Presentation to the ACRS Subcommittee

Safety Review of the Clinch River Nuclear (CRN) Site, Early Site Permit Application

Chapter 2, Section 2.5: Geology, Seismology, and Geotechnical Engineering

SSAR Figure 2.5.2-26

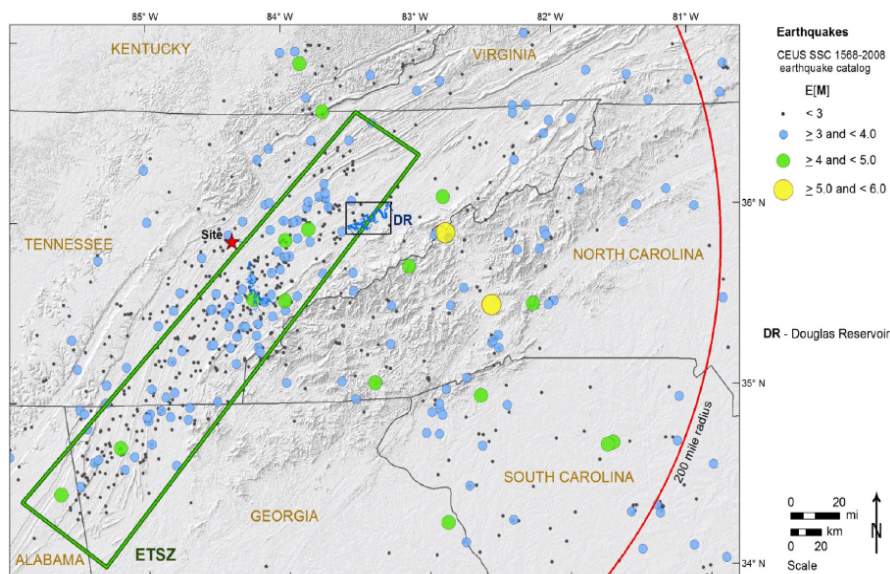
- Applicant performed two sensitivity studies following SSHAC guidance for Level II study
 - Evaluate M_{\max}
 - Evaluate Magnitude-Frequency relations
- M_{\max} values in NUREG-2115 encompass proposed M_{\max} developed using new data
- Recurrence of large magnitude events in NUREG-2115 consistent with proposed values in new geologic studies
- Staff concludes that NUREG-2115 adequately captures current understanding of seismic hazard in the ETSZ

PSHA Confirmatory Calculations

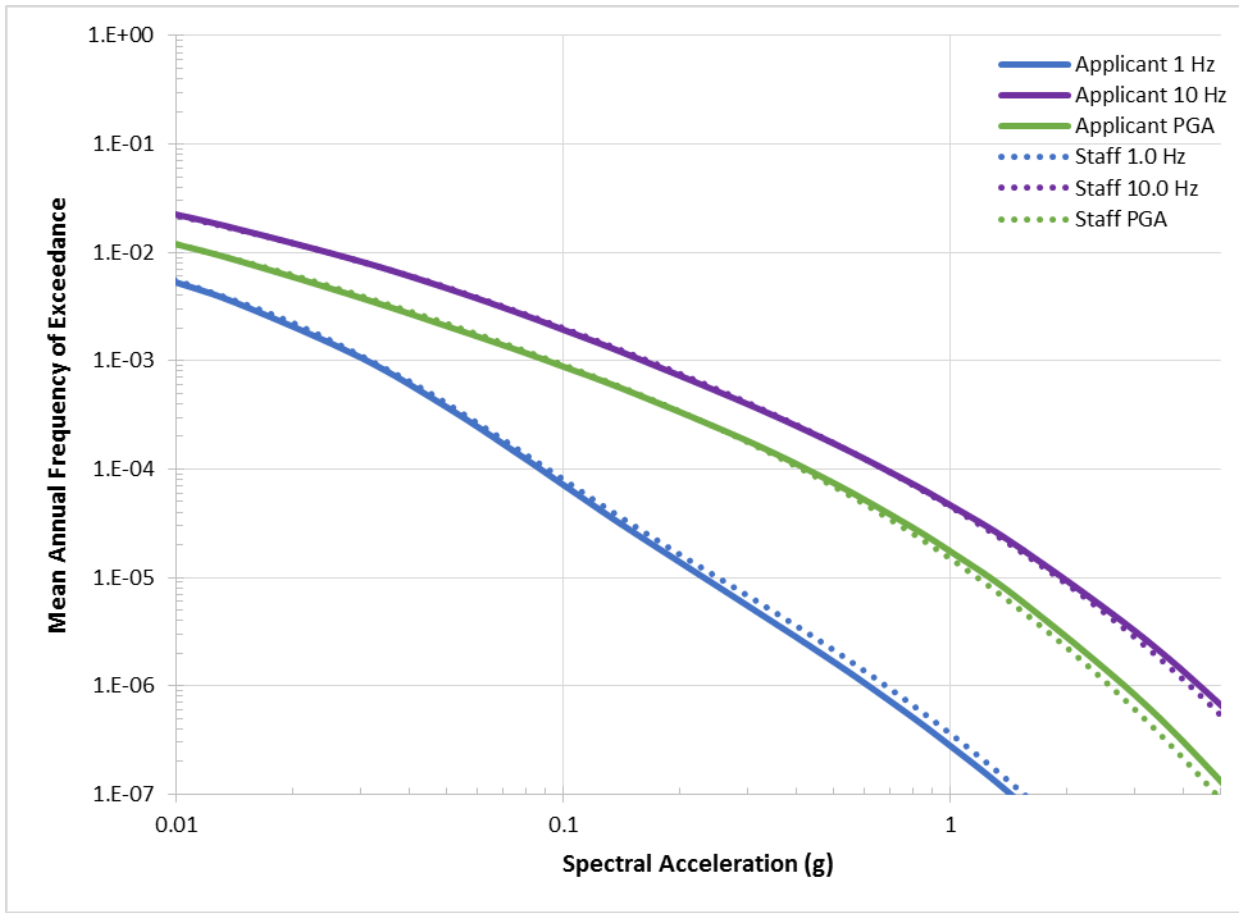
Staff independently calculated seismic hazard curves at the CRN site. Comparisons show that the seismic hazard curves are in good agreement at the annual frequency of exceedances of interest: 10^{-4} , 10^{-5} , and 10^{-6}

GMRS Confirmatory Analysis

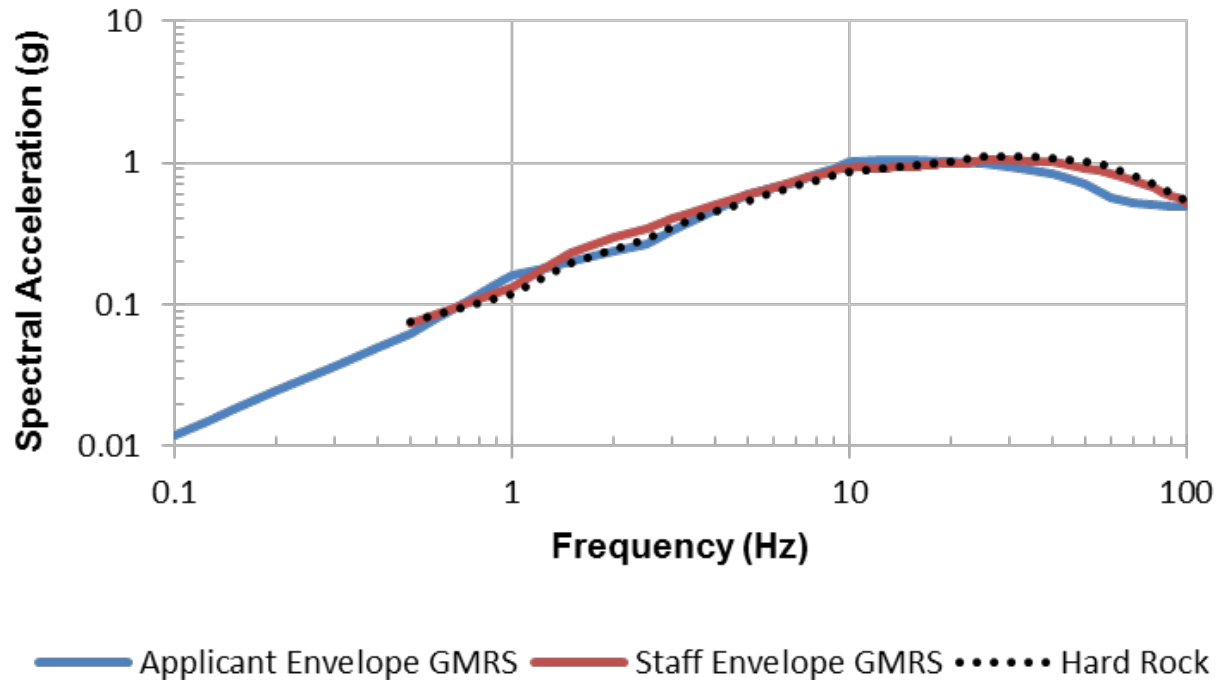
- Staff requested that applicant explain how the use of multiple base cases accurately accounts for dip across site
- Applicant responded the smearing of units is appropriate because mean and range of values at a specific depth is maintained, implicitly accounting for stratigraphic variations.

- Staff performed confirmatory site response considering dip explicitly (i.e. upsection; middle; and downsection profiles)
- Staff truncated profiles at the top of the Knox Group due to thickness and velocity of layer

- Staff's results are consistent with applicant's

Staff developed alternative input parameters for site response analysis. Staff independently calculated site response and developed a site GMRS based on its preferred inputs. Site GMRS developed by staff is consistent with that developed by the applicant

SSAR Figure 2.5.2-108

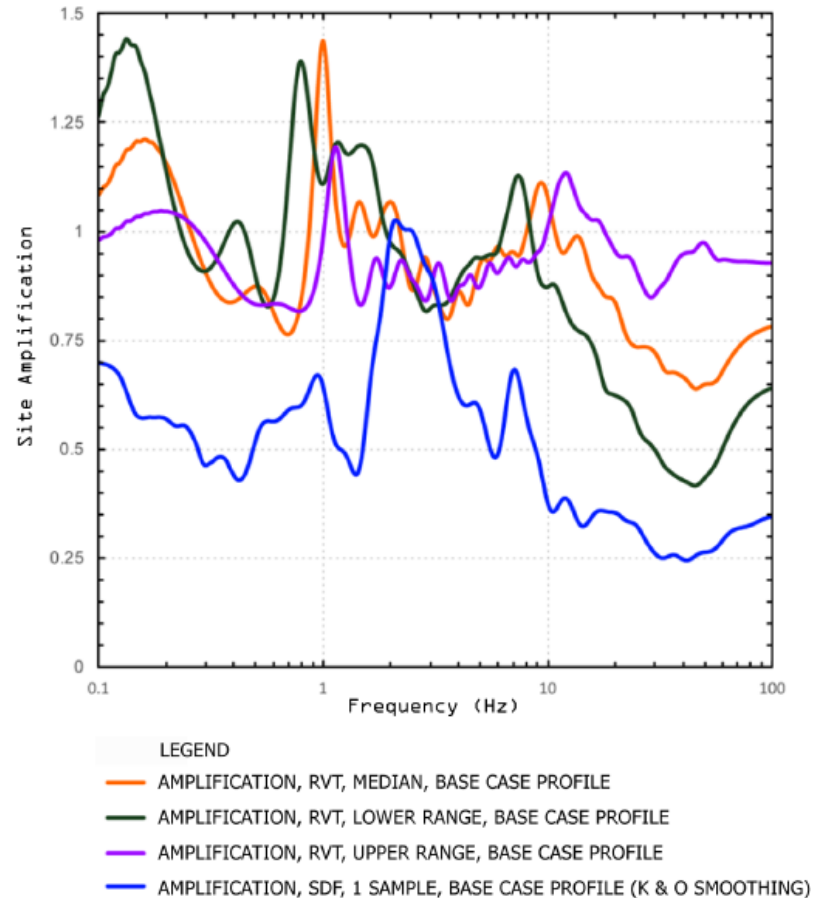
- CRN site has significantly dipping (>30 degrees) rock layers in subsurface
- RG 1.208 states that for sites with complicated subsurface structure, a multi-dimensional approach to site response may be necessary
- Applicant developed a 2-D site response analysis and compared amplification functions to 1-D results developed using 2-D inputs
- Staff requested that applicant compare 2-D results to 1-D results used in developing GMRS
- Applicant's 2-D results compare favorably with 1-D results, satisfying staff's concern
